### **ADDENDUM NO. 4**

**DATE:** February 16, 2016

RE: 2016 Waterline Replacement Project IFB-4158-16-NJ

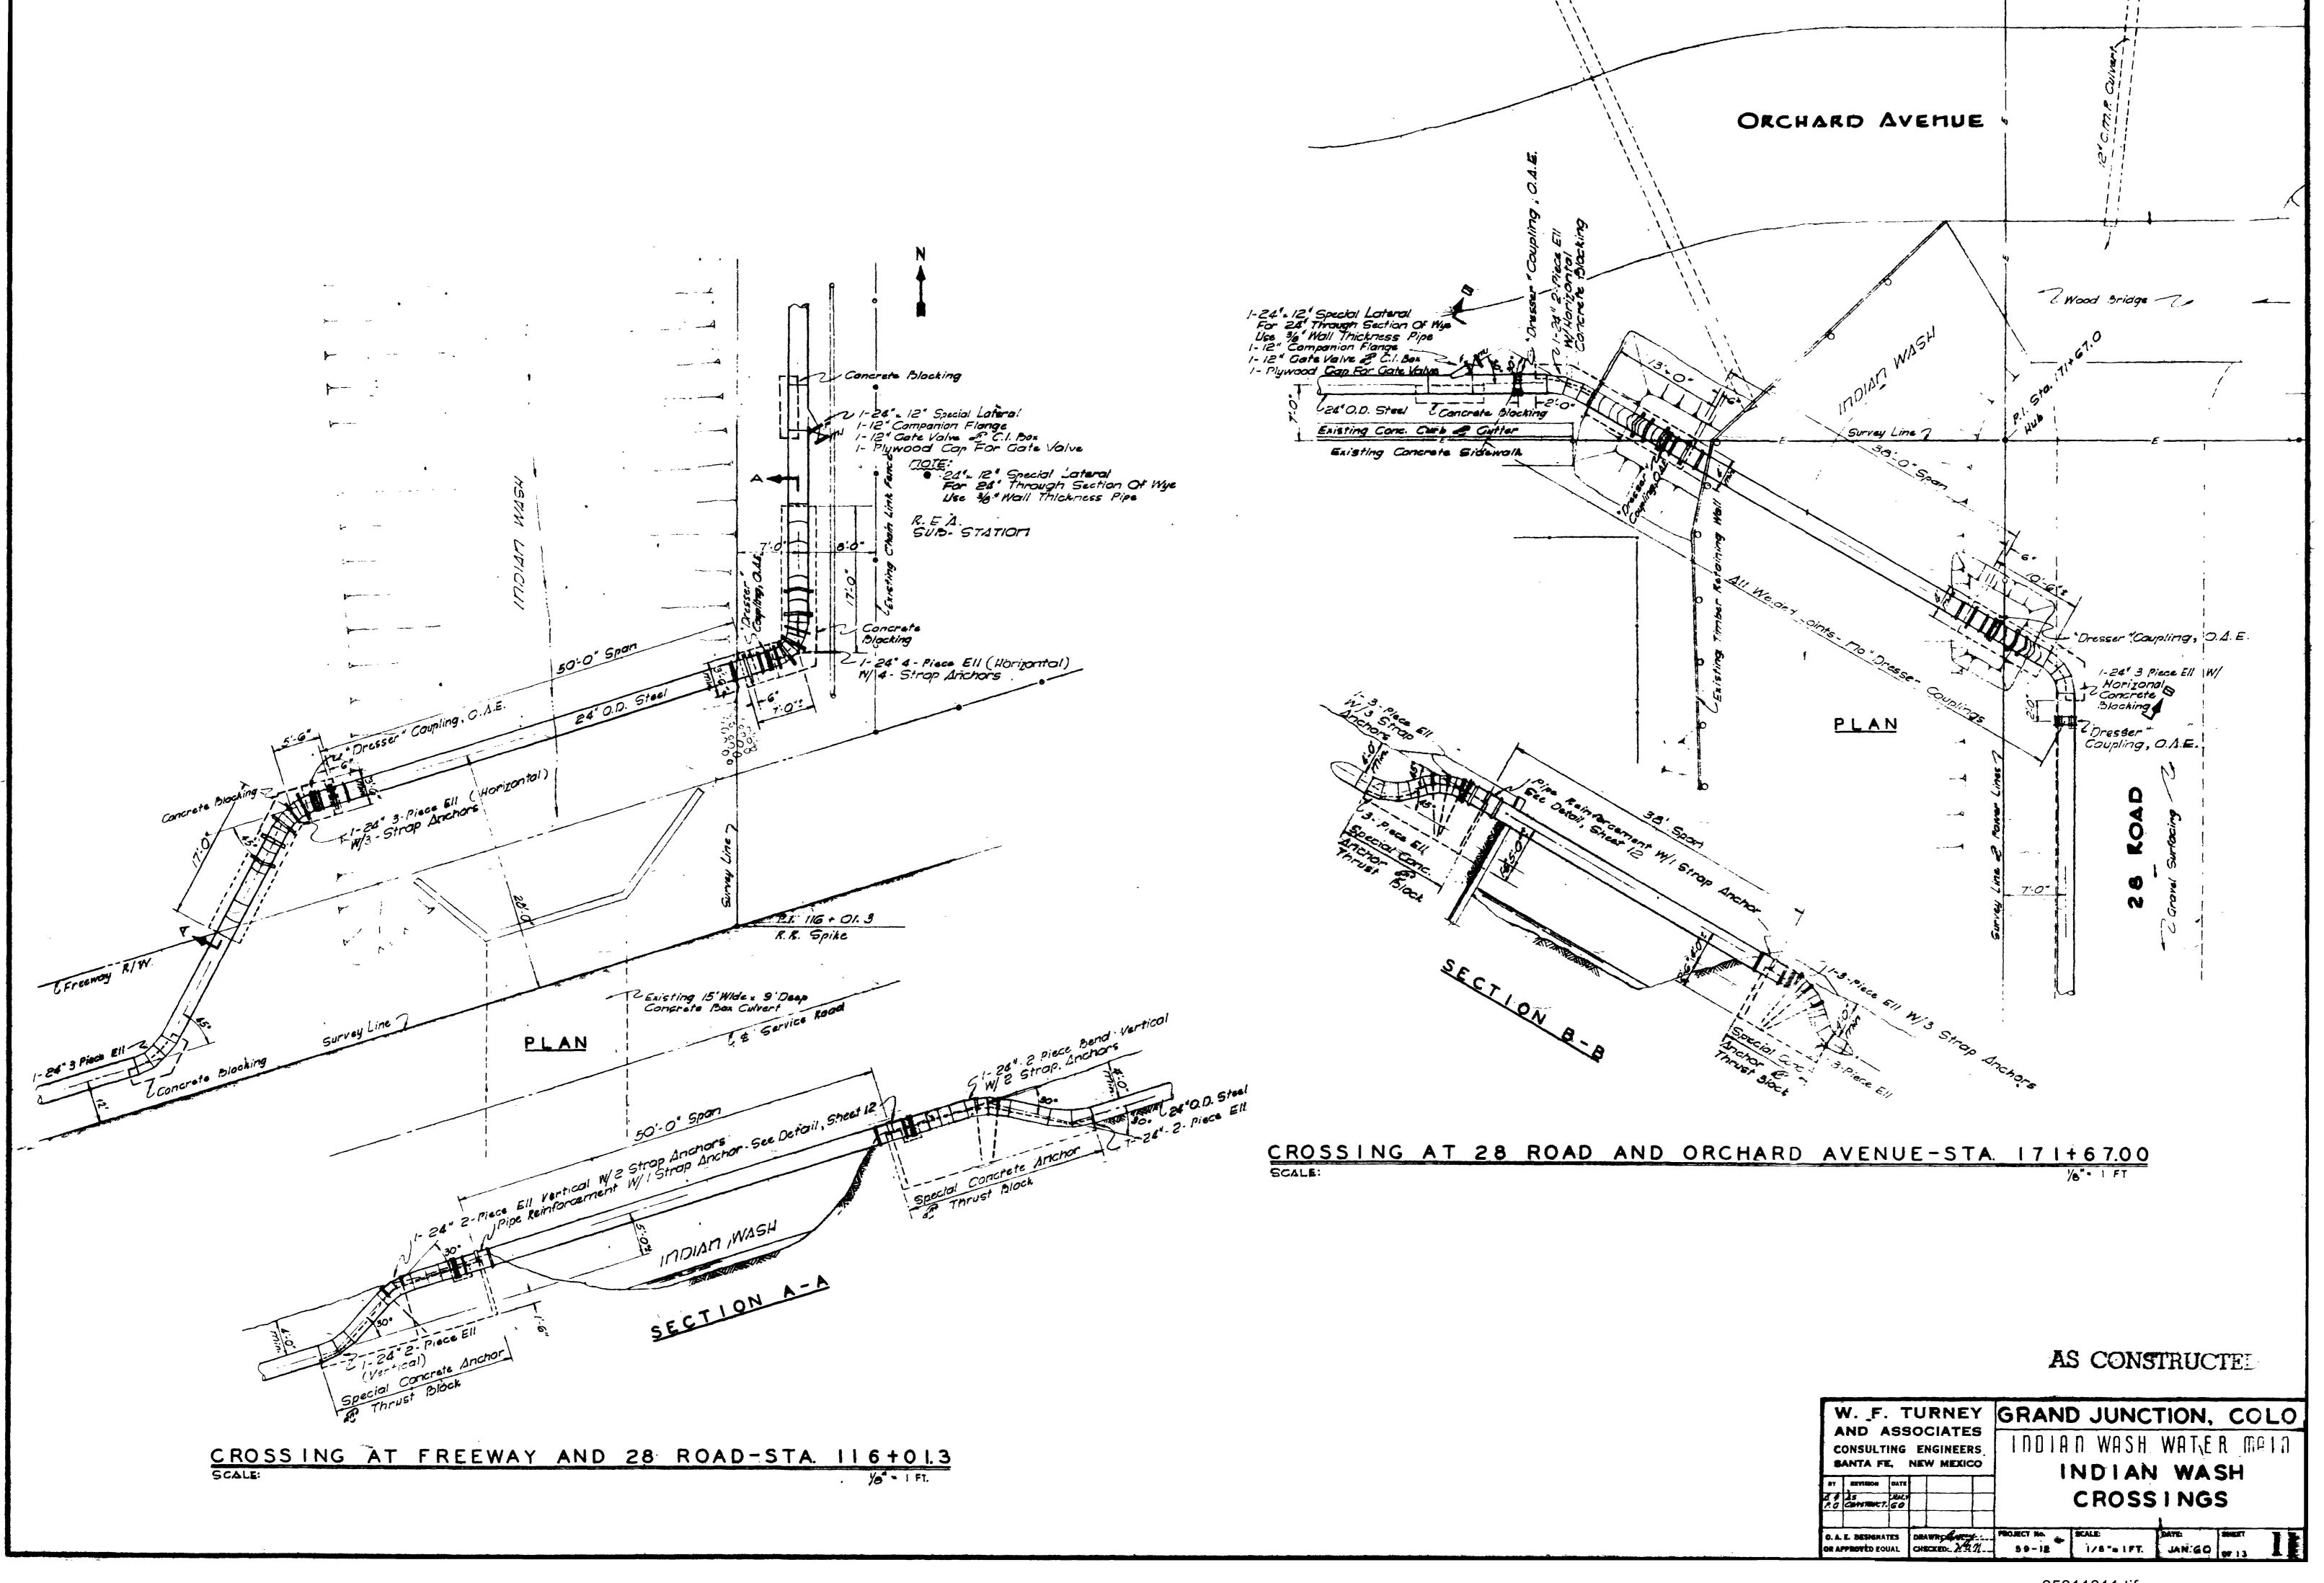
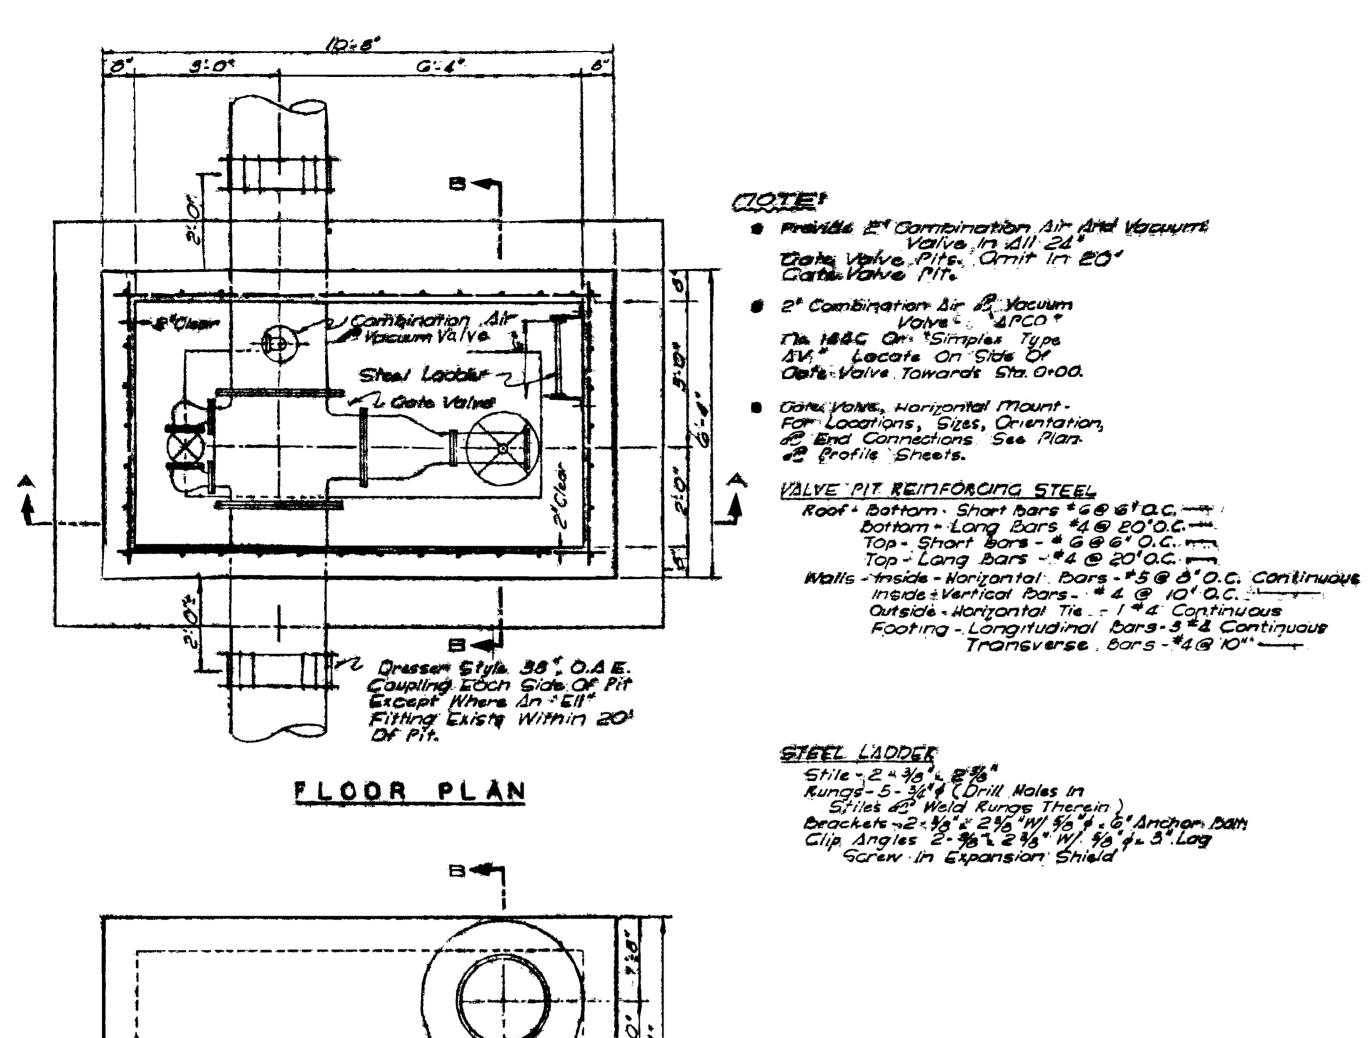
- **26. Question 26:** Sheet 6 of the drawings. Center of page showing Indian Wash Crossing detail. Note 400 states fusible 18" PVC across the wash. There is also notation with a dividing line showing fusible PVC both directions. This similar notation is also shown on Sheet 5 of the drawings in the lower right hand corner however, the note there is note 433 which is not fusible. Please clarify which type of pipe is desired to be installed across the wash and within the area of all the fittings associated with this crossing. **Response:** Please refer to the updated construction plans.

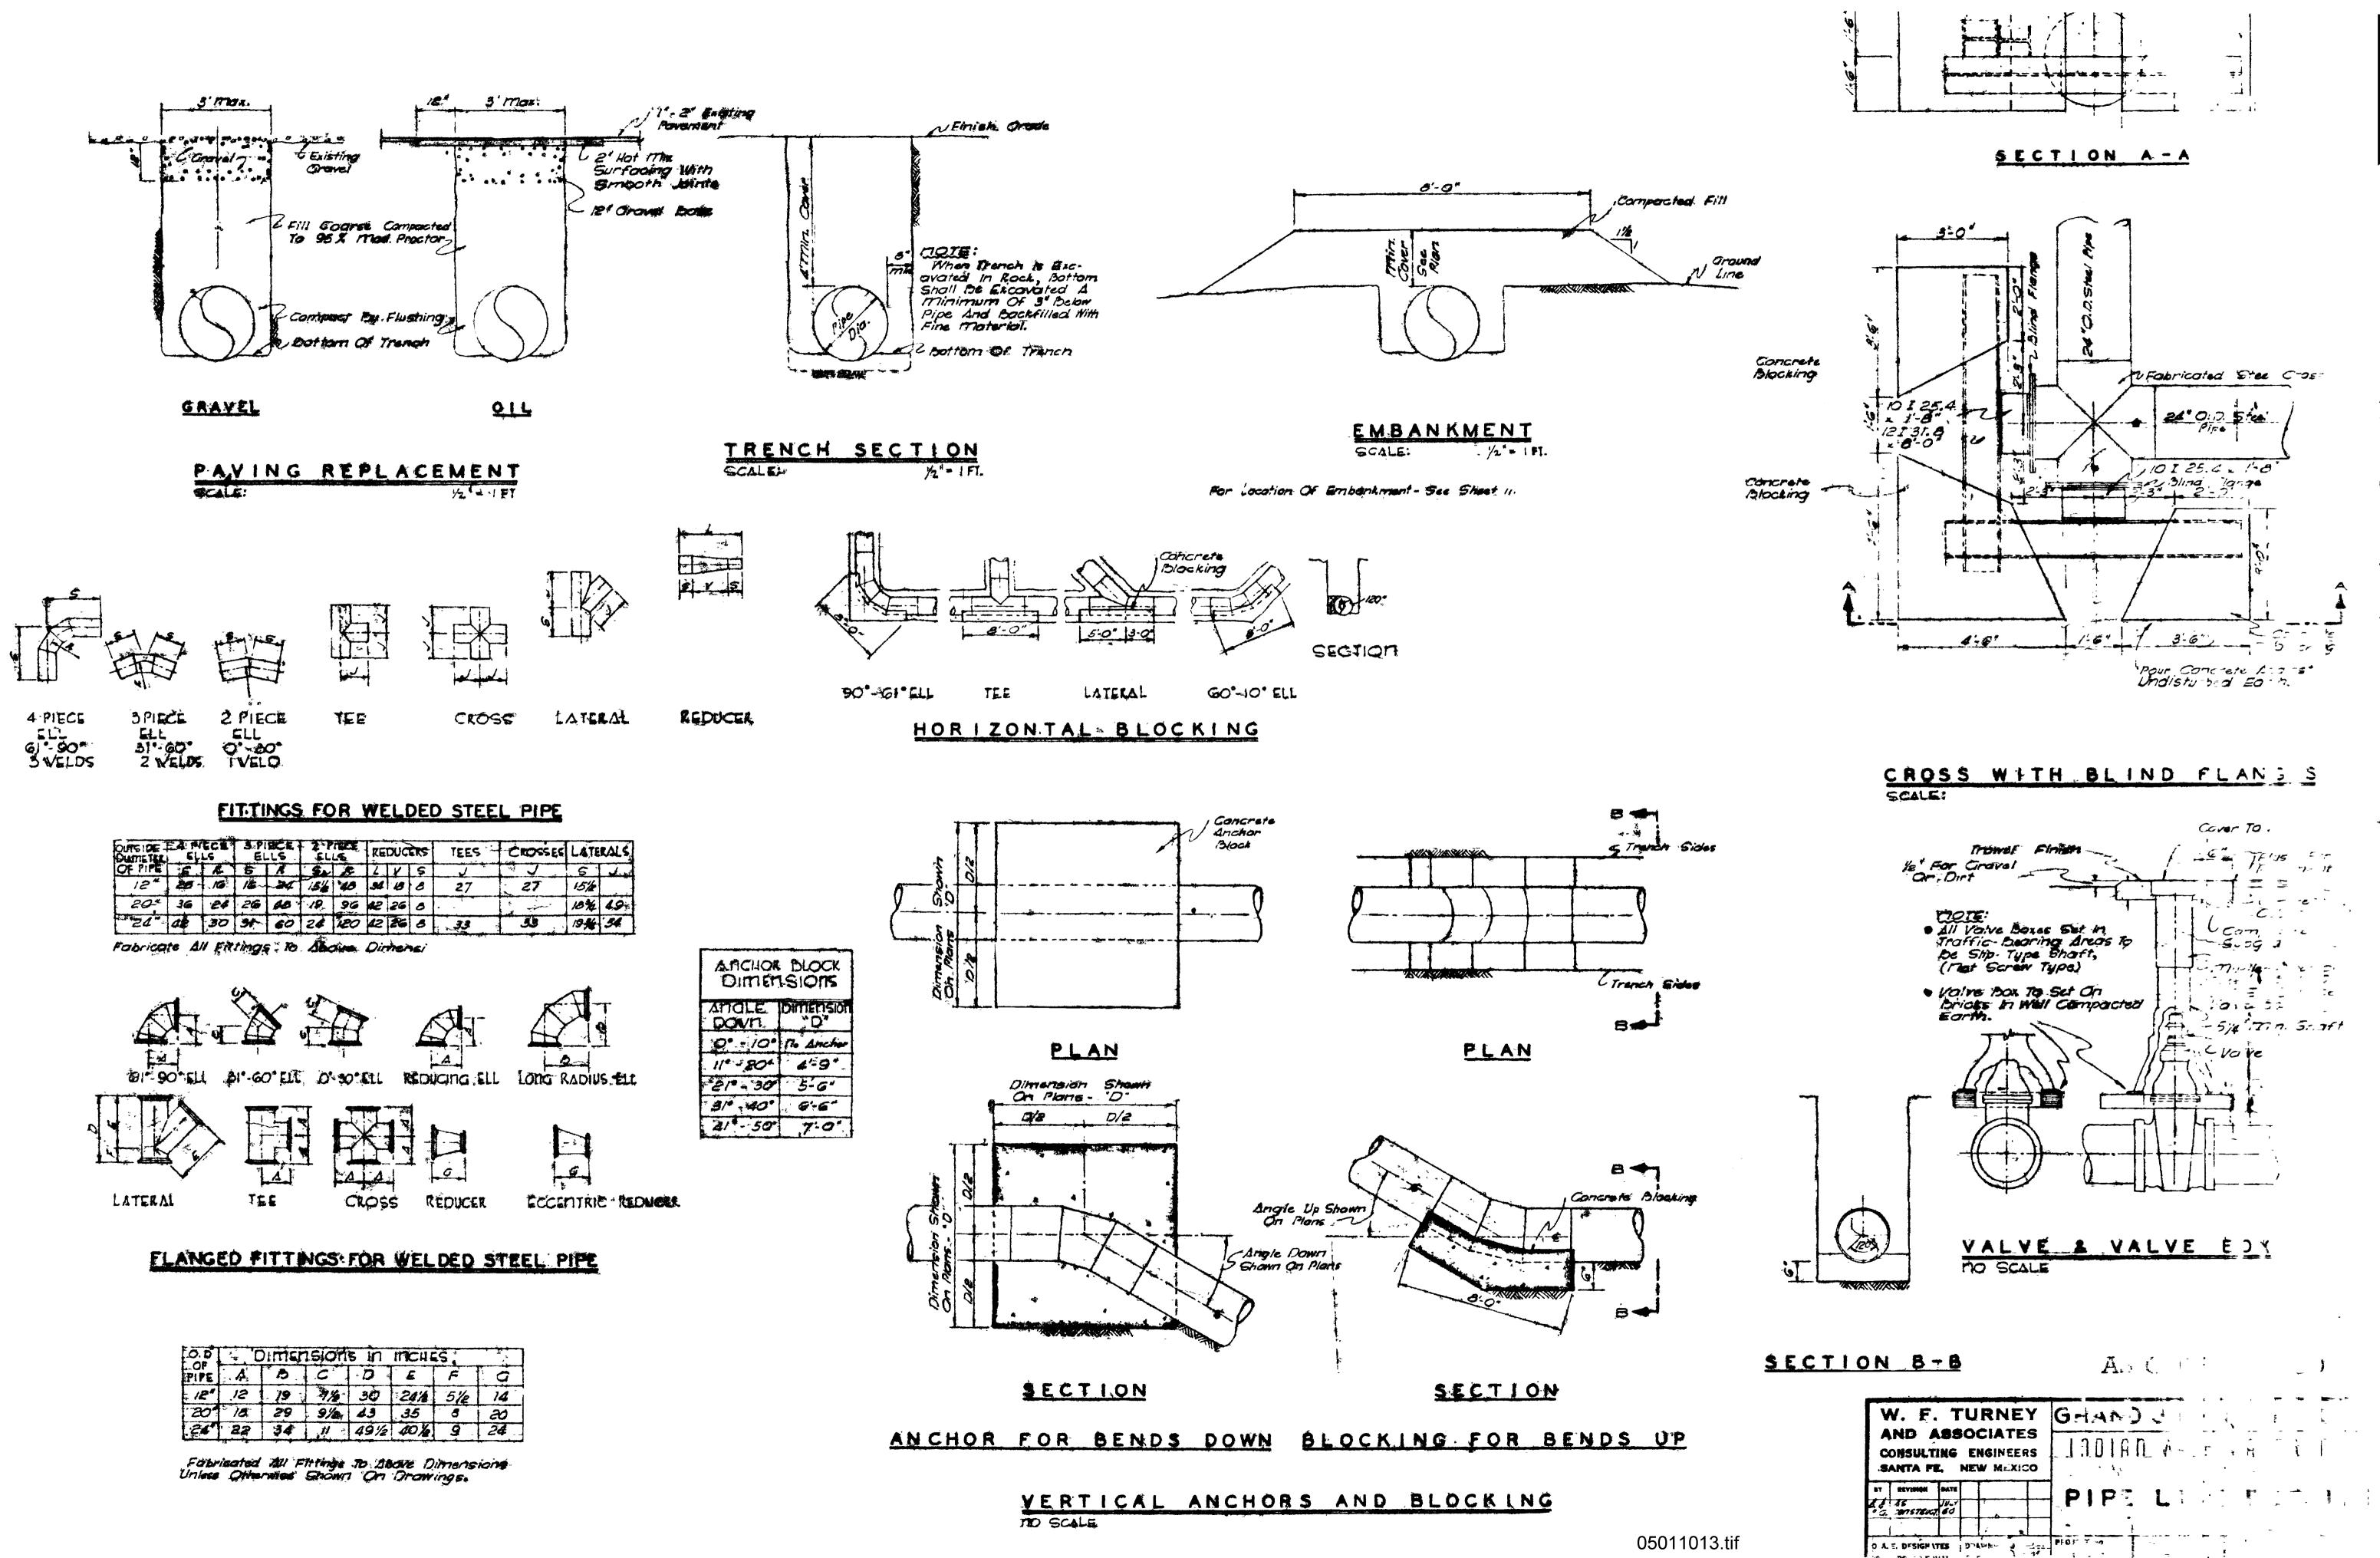
23. Question 23: On Sheet 11 of the "as constructed" drawings for the existing 24" steel line, there is a note refering to the detail for the "strap anchor" as shown on Sheet 12. Is Sheet 12 available for review of this detail? Due to the apparent size of this restraint and the note stating the removal is incidental to the pipe removal, this information would be helpful.

**Response:** Please refer to the updated construction plans.
